A30 Chiverton to Carland Cross TR010026

8.6 COMMENTS ON WRITTEN REPRESENTATIONS

Table 1 Highways England response to Written Representations

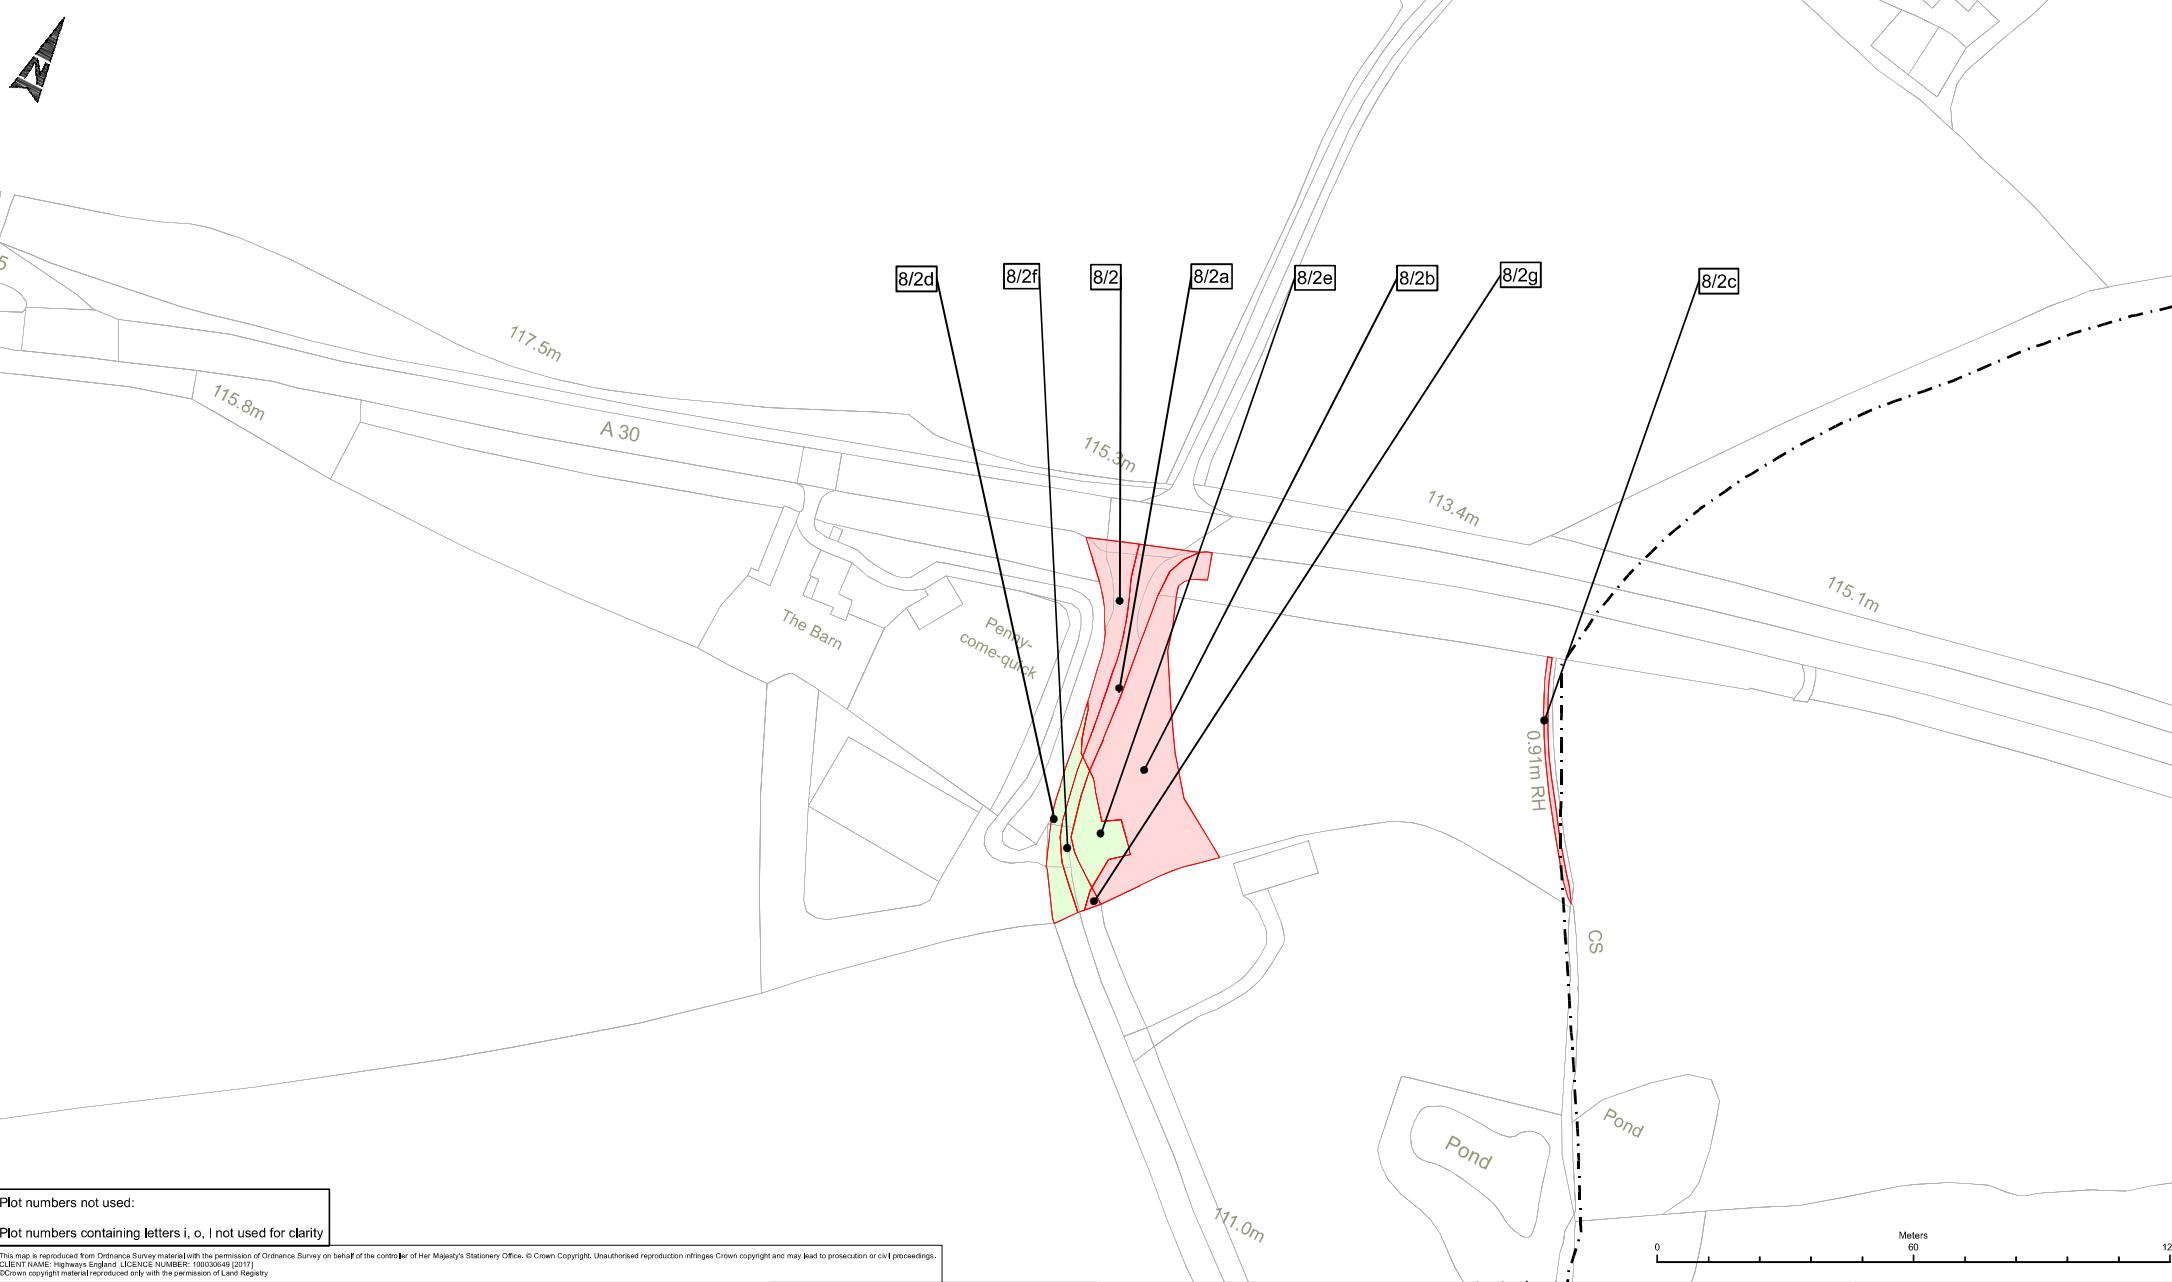
| St. Allen Parish Council Written Representation | Highways England Response |
|---|--|
| <p>The Parish Council requests that the closed section of the Shortlanesend road from St Fredas to Two Burrow Hill, which already forms part of the National Cycle Path (route no. 32), should be designated as a bridleway, making it safer for pedestrians, cyclists and horse riders to use.</p> | <p>As part of the Annex P Public Rights of Way Management Plan in the Outline CEMP Annexes (Document Reference 6.4) [APP-376] it is proposed that the National Cycle Network (NCN) continues to pass under the A30 via the Two Barrows underbridge. The route would then follow the realigned existing A30 west which would connect with the unnamed road C0364. The section of the unnamed road C0089 (Shortlanesend Road) to be closed would not be accessible from the realigned existing A30. The unnamed road C0089 would therefore only provide access to St Freda Nursery from the north via the unnamed road C0364.</p> |

| St. Allen Parish Council Written Representation | Highways England Response |
|---|--|
| | Access north-south for pedestrians, cyclists and horse riders would therefore not be available along the current C0089 (Shortlanesend Road) and instead users would follow the realigned NCN on the C0364. |
